J. JOHNSON ESTATES SUBDIVISION, **RESUBDIVISION OF**

APPLICATION NUMBER 2 DATE January 5, 2017
 APPLICANT J. Johnson Estates Subdivision, Resubdivision of
 REQUEST Subdivision

DETAIL SITE PLAN

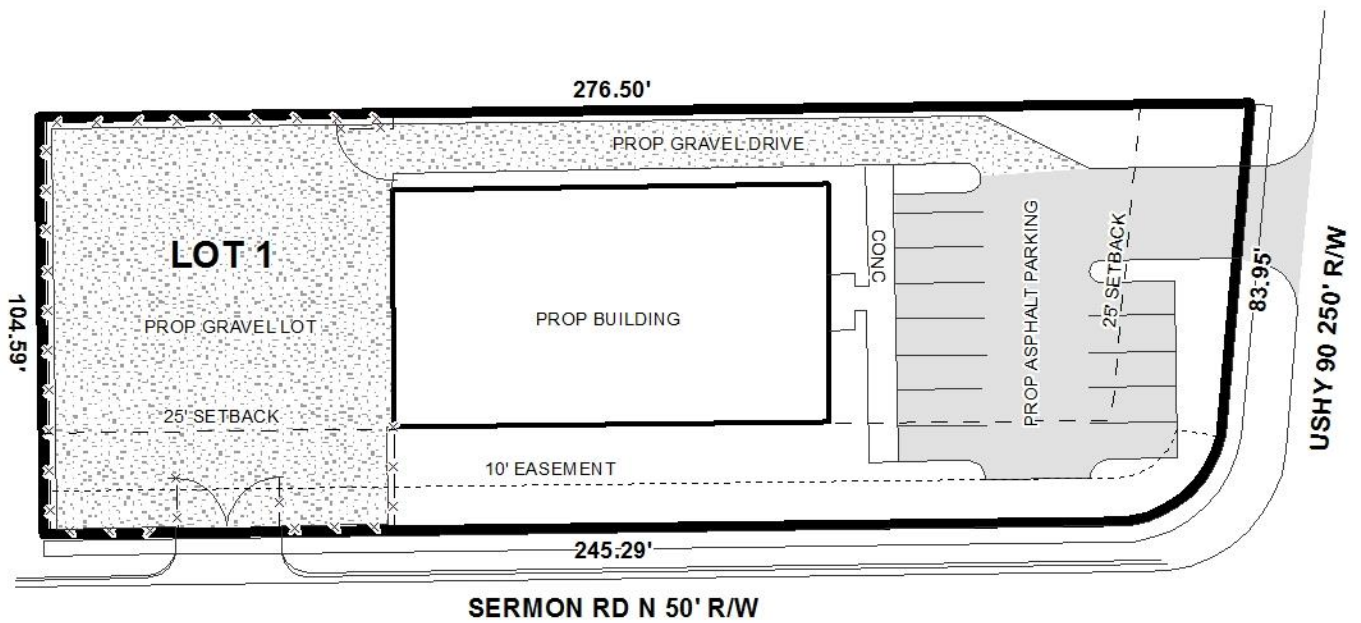
The applicant did not provide a preliminary plat, as such, but rather a site plan showing the proposed improvements to be made to the site. If approved, a Final Plat provided by a professional surveyor or engineer will be required.

The 25-foot minimum building setback line, required in Section V.D.9., is not illustrated on the site plan. If approved, the 25-foot building setback line should be shown along all frontages on the Final Plat.

It should be noted that there is a 10' drainage and utility easement along Sermon Road North, which is not illustrated on the site plan submitted. If approved, a note should be placed on the Final Plat stating that no structures are allowed in any easements.

It should be noted that the site plan illustrates a gravel driveway and laydown yard. It should be noted that gravel is not an acceptable surfacing in a B-3, Community Business District (the site's

current zoning district), and therefore the applicant would have to either apply for a variance from the Board of Zoning Adjustment, or utilize a compliant surfacing material.

A sidewalk waiver was approved by the Planning Commission at its November 1, 2012 meeting; however, the new application negates the previous waiver. As such, a sidewalk will be required as illustrated on the site plan submitted.

- 1) retention of the 25' minimum building setback line along all street frontages;
- 2) provision of the lot size in square feet and acres;
- 3) illustration of the lot sizes in square feet and acres;

- 4) illustration of all easements on the site;
- 5) placement of a note stating that no structures are allowed in any easement;
- 6) placement of a note on the Final Plat stating that the site is limited to one curb cut per street frontage, with size, location and design to be approved by Traffic Engineering and conform to AASHTO standards;
